Please consider this an observation submitted in response to the Newspaper Notice in the Connacht Tribune on 14/05/2026 related to Appeal Reference Number **ABP-320916-24**.

Long duration energy storage facility within an outdoor compound and a synchronous condenser positioned within a building and located within a second outdoor compound, together with all ancillary works. Environmental Impact Assessment Report and Natura Impact Statement submitted with application.

ABP-320916-24

Observation Submitted By:

Figure 13.1 Site Location

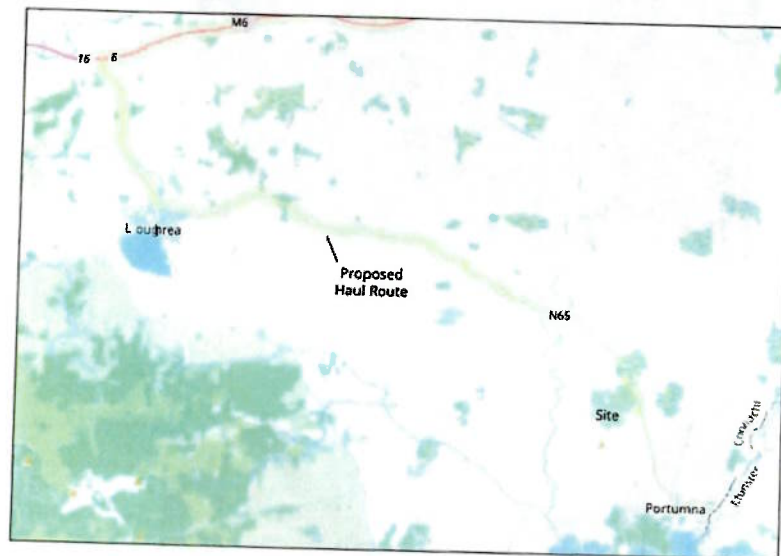
With the above in mind, I refer the planner to the developer's EIAR Addendum and its complete sidestepping of any traffic impact on the village of Killimor some 3.5km away from the proposed site and directly on the proposed haul route.

While the developer has noted the virtues of the proposed haul route avoiding travelling through the towns of Loughrea and Portumna⁴³, it has completely ignored any impact on the village of Killimor. The oversight goes as far as ignoring Killimor on the traffic associated maps as can be seen below.

The closing paragraph of section 13.4 of the latest EIAR doubles down on this oversight. This is very curious given the regular references to Killimor when detailing the site location in other areas of the EIAR.

Loughrea is located approximately 25km to the north-west of the Coolpowra site and Portumna is located approximately 5km to the south of the proposed development lands. The traffic consultant was informed that the intended haul route (as shown on Figure 13.1) is via the M6 to Junction 16 (Kiltullagh) and N65 and therefore does not pass through either Loughrea or Portumna. Should permission be granted for the development, a

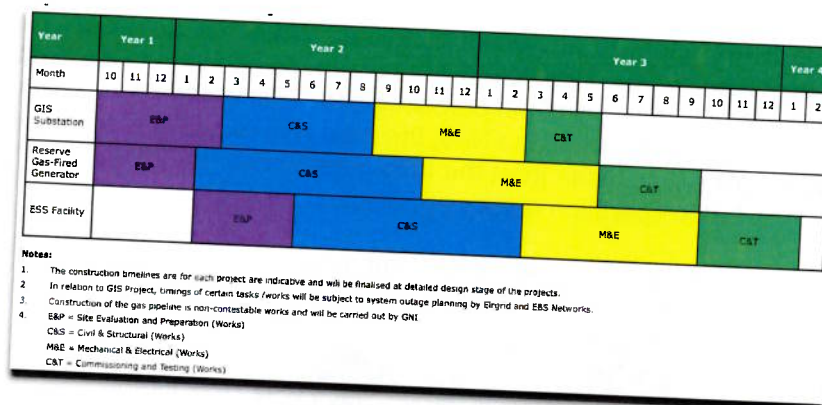
After analysing the site investigation information, and reviewing the proposed construction drawings, one finds that at least 269,662.54 of fill is required. A typical HGV carries 8m³ in a single load. Therefore, rather than 7,647 deliveries of fill being required, over 33,708 will be. That is 26,060 additional HGV deliveries to site. That would be an additional 26,060 HGVs travelling through Killimor and then access and egressing a new entrance formed on the N65. That would be an additional 26,060 HGV deliveries for just the fill element of the works. We have no data to check if the remaining HGV estimates are solid or not. We also know that the cut and fill requirements for the proposed new access road have not been taken into consideration in the EIAR. As per Table 7.5 in that document, only the original road alignment has been considered.

In the absence of the required data (and ignoring the omission of the new road requirements), if we are to assume that the remaining HGV estimates are sound, we now know that a minimum of 42,860 HGV deliveries is required for this project (16,800 as per the EIAR information + 26,060 shortfall in fill calculation).

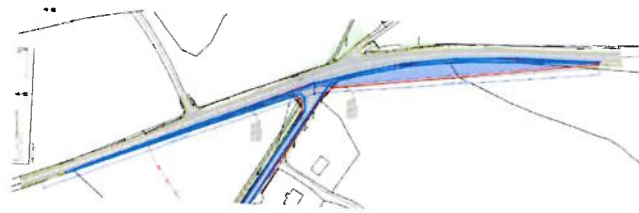
- The developer's latest EIAR makes the case that sightlines at the N65/L8763 junction can still be achieved despite landowner consent for access having been withdrawn. This argument is incorrect.

Page 3-8 item (a) suggests that maintenance of hedgerows to the north of the junction will provide adequate visibility. This is demonstrably incorrect. It is probably best proven by utilising the developer's own drawing, CPA-HAL-OC-XX-DR-PL-1010D. Note the length of sightline deemed required to the north of the junction, and the land take associated with that.

Figure 1.3 Indicative Gas Pipelines Routes

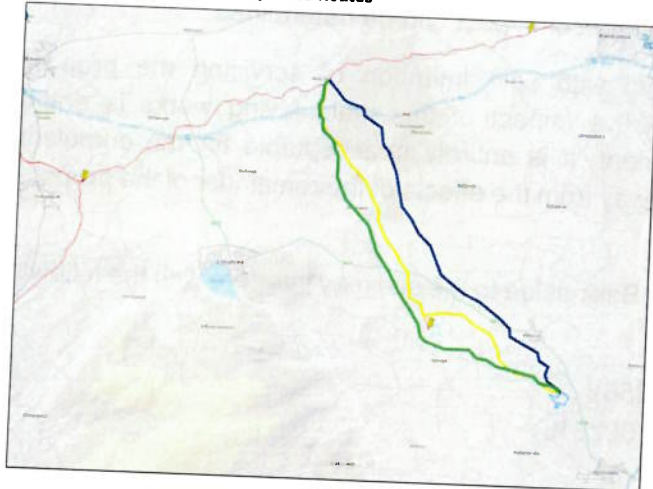
In the initial EIAR, the potential gas main routes were outlined on the drawing below⁵⁰. The indicative route suggested a gas supply from the existing main in New Inn.

Section 7.1.1.1 of the 2024 EIAR stated the following:

The indicative route for an associated gas pipeline has been considered as part of this assessment. This will commence at New Inn, just north of the M6 Motorway and approximately 23.5 km north-west of the development site. The pipeline will be established by Gas Networks Ireland (GNI) through a separate planning application, and this will complete a full assessment of the preferred route associated full assessment.

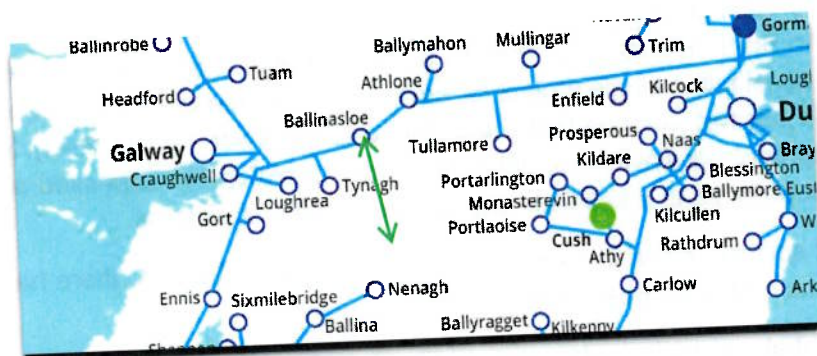
At the developer's request, GNI commenced a process in selecting the preferred gas main route. A public meeting was held in Kiltormor on 20/05/2025. At that public meeting, GNI explained that the preferred gas main route would now be via Ballinasloe. At that meeting, GNI confirmed that they had advanced the route selection works at the request of the developer. The developer's aim was to mitigate delays if and when planning permission was awarded. Presently, the route selection has been advanced to a stage where GNI are discussing Terms and Conditions with local landowners about laying the main through their lands. An indicative route is offered on drawing below in green arrow. The route will be approx 25km. It's indicative as the developer has not furnished updated information.

Despite all these substantial developments, the developer's latest EIAR has not in any way shape or form informed the planner of these changes. Furthermore, the proposed route is now well enough established that a full assessment of impact can be determined.
